Project	IEEE 802.16 Broadband Wireless Access Working Group < http://ieee802.org/16 >	
Title	Restructuring and Renaming of Management Primitives in section 14.2.9	
Date Submitted	2006-05-05	
Source(s)	Jaesun Cha	jscha@etri.re.kr
	ETRI	
	Ronal Mao	rmao@huawei.com
	Huawei Technologies Co., Ltd.	
	Ronny (Yong-Ho) Kim	ronnykim@lge.com
	LG Electronics, Inc.	
Re:	Contribution on comments to IEEE 802.16g/D2	
Abstract	In this contribution, we propose to define some primitives for Neighbor BS Management.	
Purpose	Adoption	
Notice	This document has been prepared to assist IEEE 802.16. It is offered as a basis for discussion and is not binding on the contributing individual(s) or organization(s). The material in this document is subject to change in form and content after further study. The contributor(s) reserve(s) the right to add, amend or withdraw material contained herein.	
Release	The contributor grants a free, irrevocable license to the IEEE to incorporate text contained in this contribution, and any modifications thereof, in the creation of an IEEE Standards publication; to copyright in the IEEE's name any IEEE Standards publication even though it may include portions of this contribu

Figure 505 — The use of primitives to generate MAC management messages

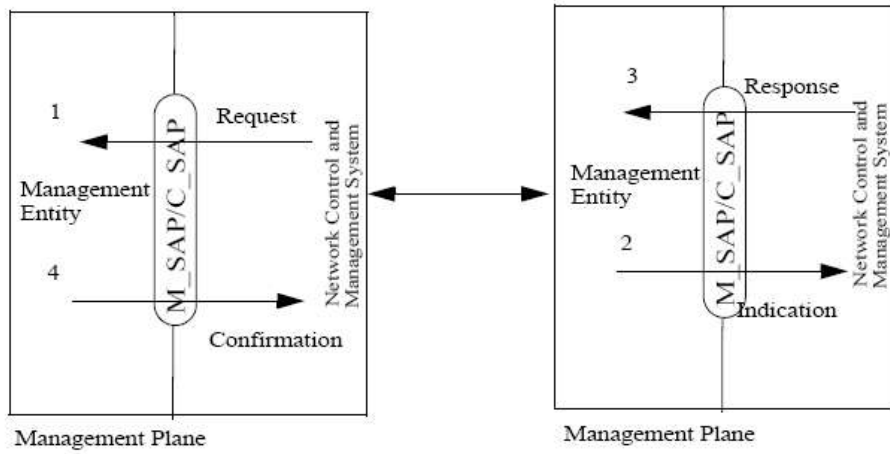
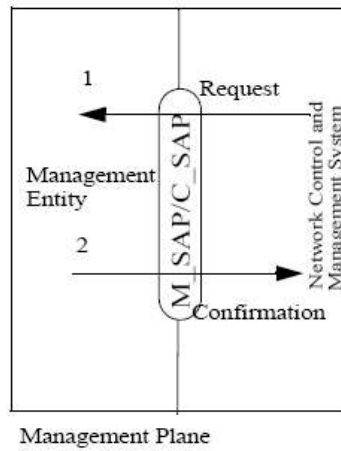
~~The IEEE 802.16 MAC shall support the following primitives which are delivered through C-SAP (Control Service Access Point) or M_SAP (Management Service Access Point) interfacing with NCMS (Network Control and Management System):~~

~~The use of these primitives to provide peer communication is shown in Figure 3. The use of primitive can be divided into two categories. The first category is with interaction with the peer entity, and the second category is primitive exchange within local stack.~~

~~The initial request for service from a higher layer through NCMS is provided by the "Request" primitive. The request triggers to generate appropriate MAC management message and the MAC management message is sent across the air interface to the peer MAC.~~

~~Upon reception of the MAC management message over the air interface, corresponding "Indication" primitive is generated to inform NCMS of the request; When the response for the request is made from the higher layer, the response is delivered through the NCMS by the "Response" primitive. The response triggers to generate appropriate response MAC management message and this message is transmitted over the air interface to the originating side. Upon reception of the response MAC management message over the air interface, corresponding "Confirmation" primitive is generated and delivered to higher layer via NCMS.~~

~~Primitives exchange for the unidirectional MAC management messages, which don't require response messages, such as MOB_HOIND, MOB_TRF-IND, and for the local management of the MAC state machine, is shown in Fig. 3, (2). The initial request for service from a higher layer through NCMS is provided by the "Request" primitive. The request triggers either to generate appropriate unidirectional MAC management message or MAC state change depending on the primitive. "Confirmation" primitive conveying the result of the request is delivered to the higher layer through NCMS.~~

Figure 506 — The use of Ranging Primitives [Figure 506a Ranging Primitives \(MS Side\)](#)

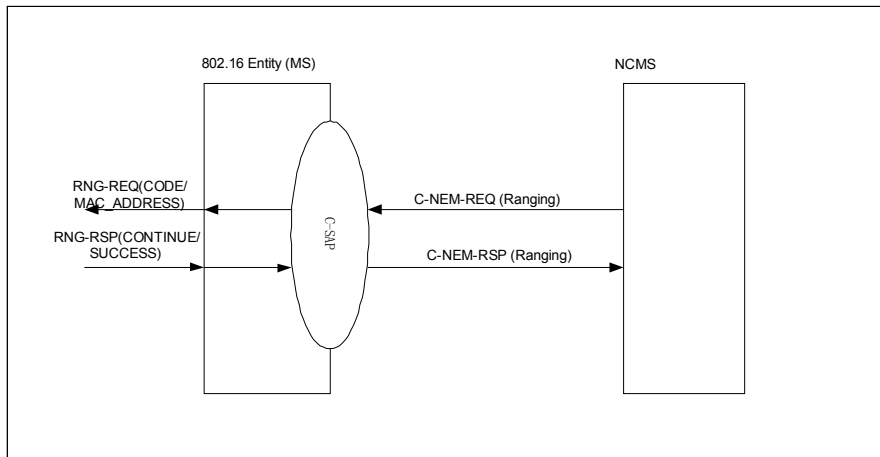
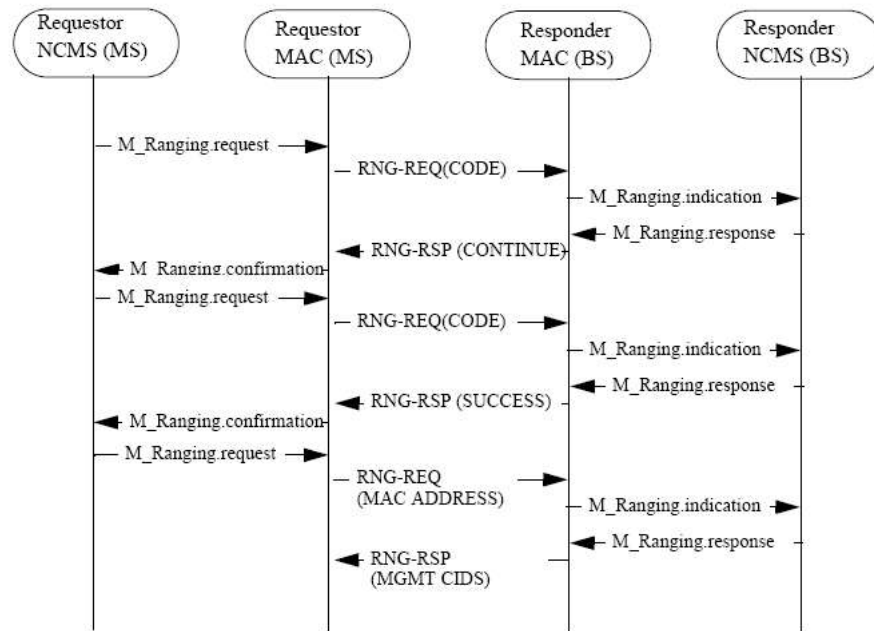
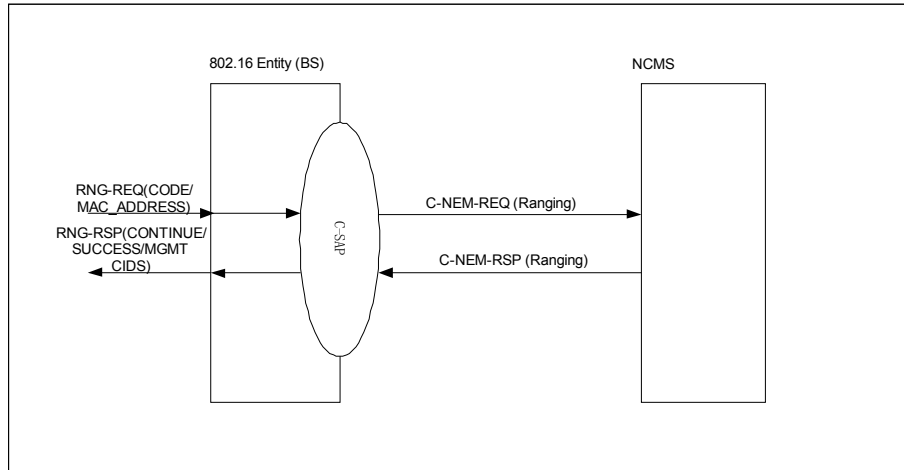
14.2.9.1 M_Ranging.request/indication/response/confirmation C-NEM-REQ Ranging Primitives

This primitive is used by the NCMS or the 802.16 Entity to control ranging or registration network entry procedures. The Action Type included in this primitive defines the type of network entry procedures to be performed. The possible Action Type for this primitive are listed in Table below:

Upper layers can control ranging procedure with these primitives. Upper layers shall commence 802.16 link setup procedure by sending C-NEM-REQ(Ranging)M_Ranging.request primitive through NCMS.

Figure 507 – The use of Registration Primitives [Figure 507a Registration Primitives \(MS Side\)](#)

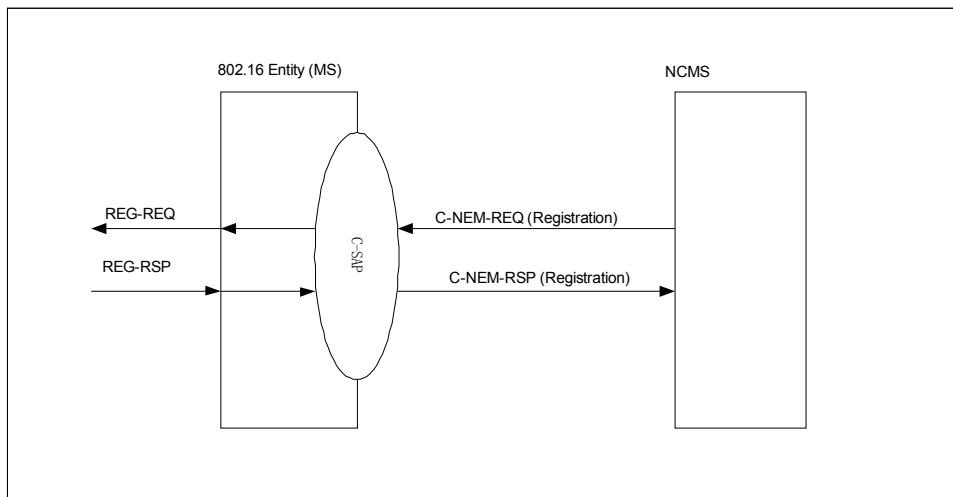
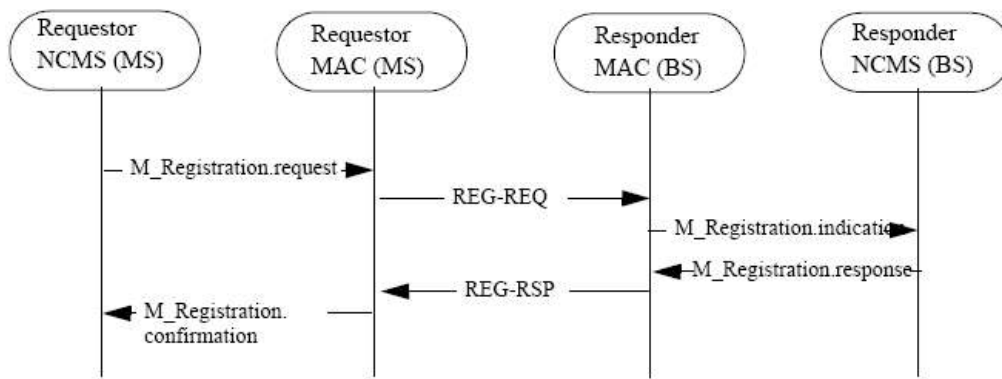
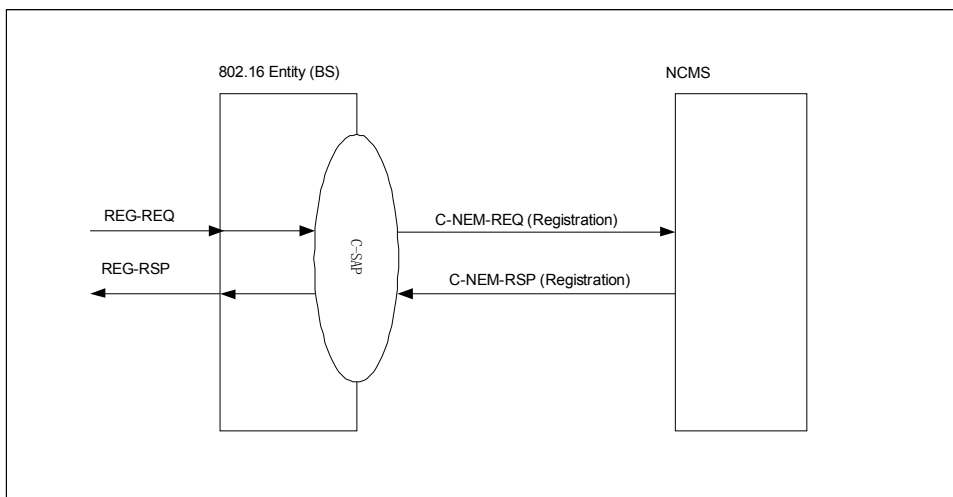
14.2.9.2 M_Registration.request/indication/response/confirmation~~Registration Primitives~~

~~Upper layers can control registration procedure with these primitives. Upper layers are notified of link setup by M_Registration.confirmation. C-NEM-RSP/Registration.~~

Figure 508 – The use of Neighbor Advertisement Indication Neighbor Advertisement Primitives

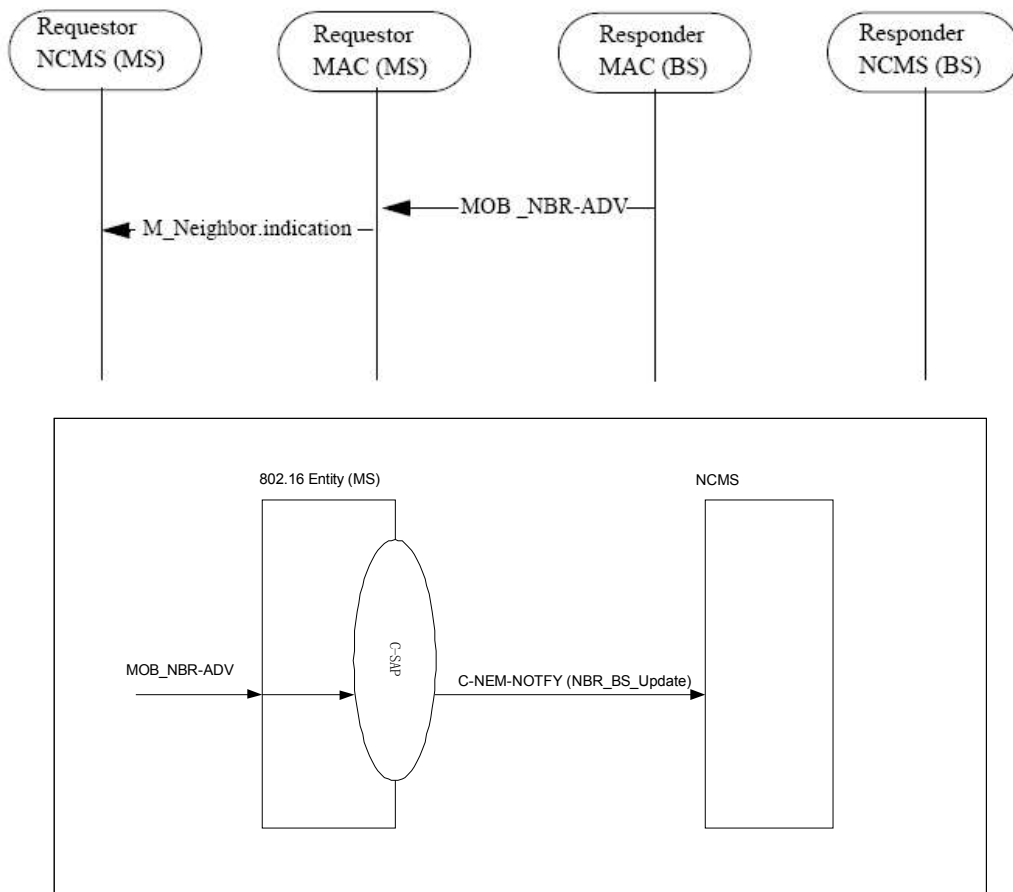
14.2.9.3 Neighbor Advertisement Primitives M_Neighbor.indication

14.2.9.3.1 M_Neighbor.indication C-NEM-NOTFY

Figure xxx – Mobile Terminal Management primitives flow between 802.16 Entity and NCMS, De-Registration

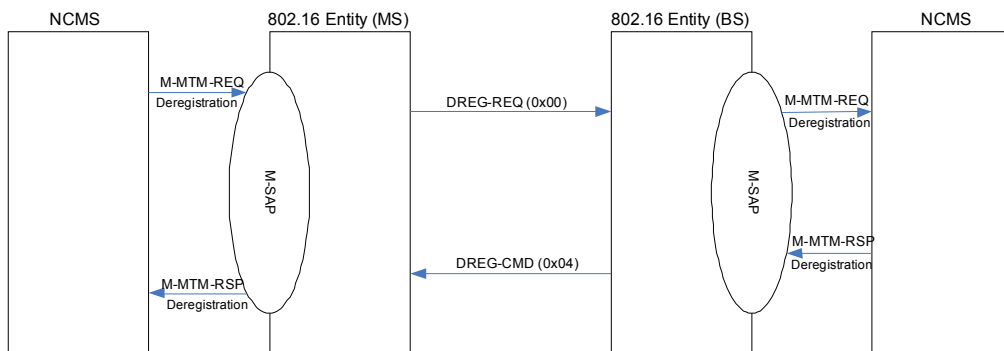
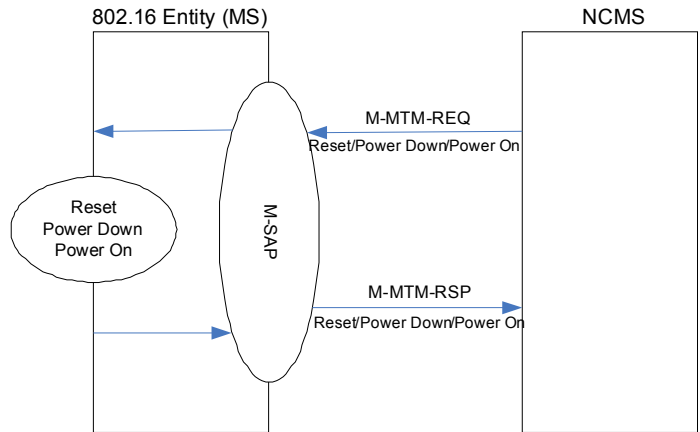
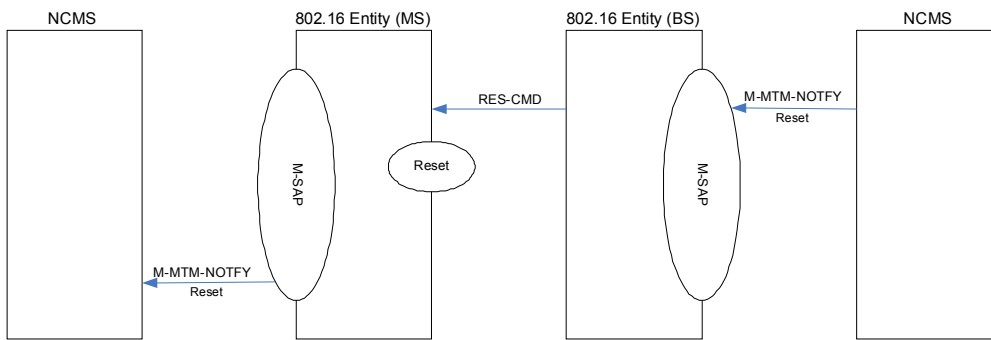
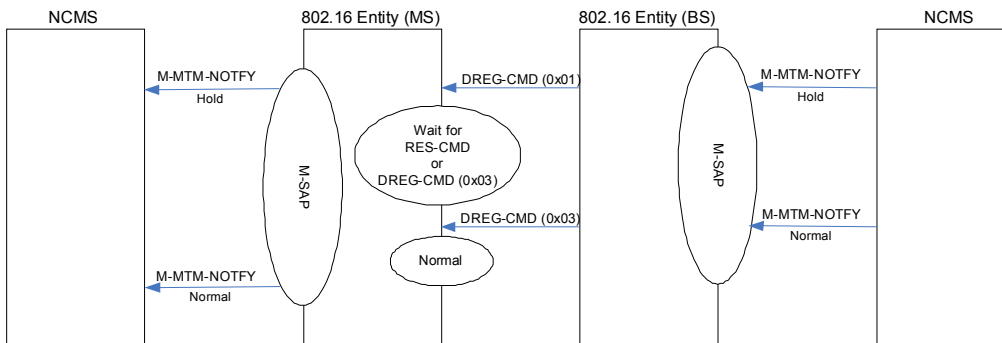
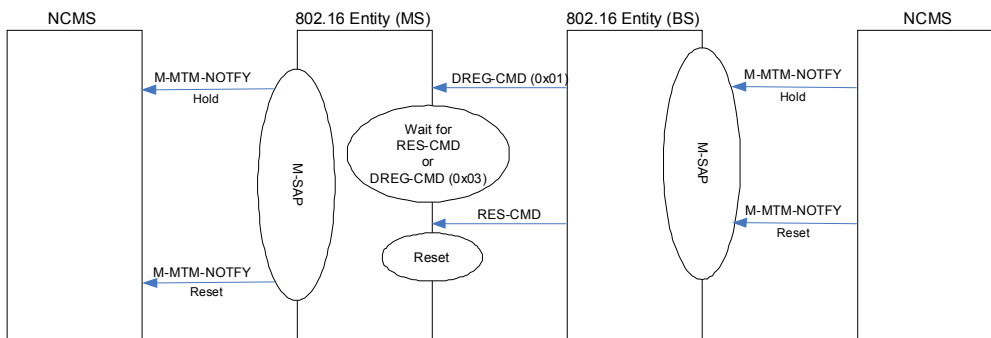
[Create a New Section 14.2.10 as follow]

14.2.10 Mobile Terminal Management

The Mobile Terminal Management Primitives are a set of primitives to manage the status of mobile terminal. A management entity in NCMS can change the status of mobile terminal into power on/down/de-register, etc. Those primitives are also used to notify NCMS of information or events which are related with the status of mobile terminal.
